Crab cavity vacuum

Meeting Notes, 19/6/2015

Figure 1: sector valve layout, with the plugs used as sector valves.

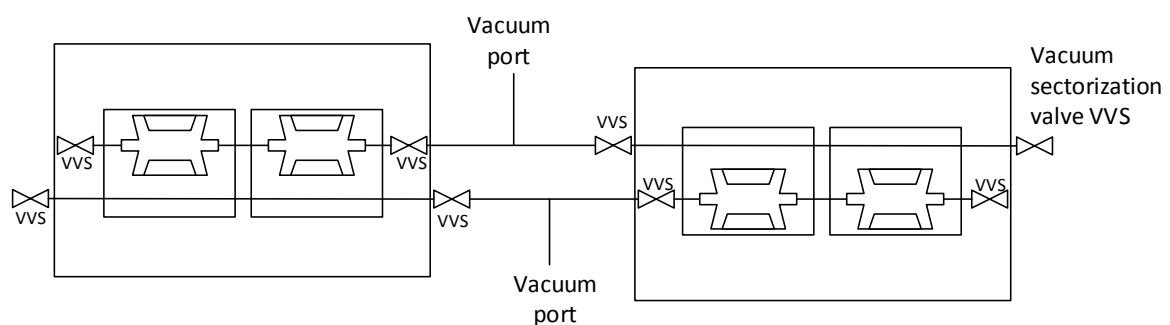
However, a sector valve needs to be interlocked by vacuum measurement immediately upstream of it, via a vacuum gauge, to ensure that no pollution of a clean vacuum occurs upon opening. Now, the Penning gauge on the Fundamental Power Coupler is not suitable for this scope, as vacuum conditions at the power coupler are not representative of those in the immediate proximity of the gate valve: indeed, the cold cavity in between constitute a huge cryopump. In addition to a vacuum gauge, a pumping port is also necessary, to restore vacuum in case of failure, for instance a power cut with subsequent warming up of the cavities. An additional vacuum port, accessing beam vacuum close to each sector valve, is then necessary. The cavity string would be transformed as follows:

Figure 3: Vacuum sector valves are distinct from plugs. An additional port, outside the cryostat, gives access to beam vacuum between sector valves for roughing and UHV pumping and monitoring, both for the cavity beam line and for the drift line.

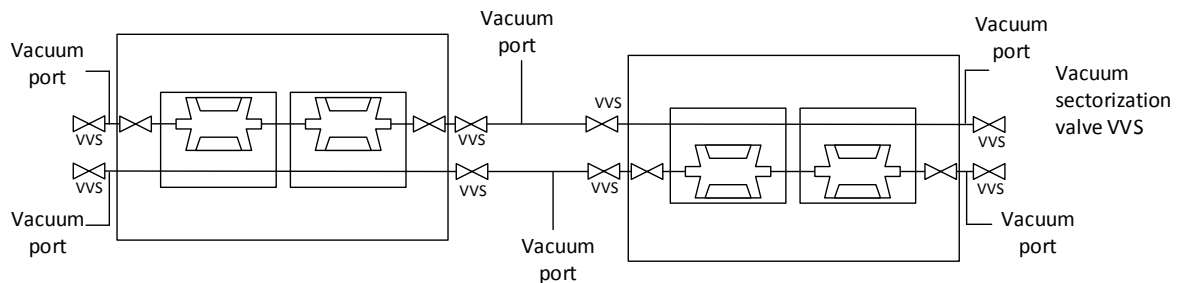
While the first alternative (plug-off and sector valves functionalities all-in-one) presents the advantage to spare 2 valves per cryomodule, it complicates integration of an additional vacuum port in the internal tight volume of the cryomodule. The second solution (separation between plug-off and sector valve) impacts on the warm section's integration and adds one valve, but preserves the cryomodule.

The second alternative seems preferable. Integrity of the plug-off gate valves is ensured by the use of the Penning gauge integrated in the FPC to check vacuum between the closed plugs before opening.

Figure 4: SPS vacuum layout for the Crab cavity cryomodule test

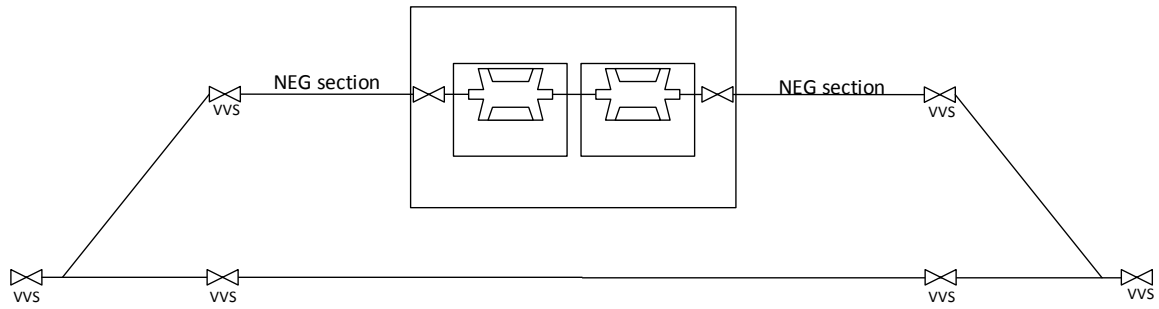
In SPS, the drift vacuum tube will not be present. The SPS vacuum layout follows the same logics as the second alternative:
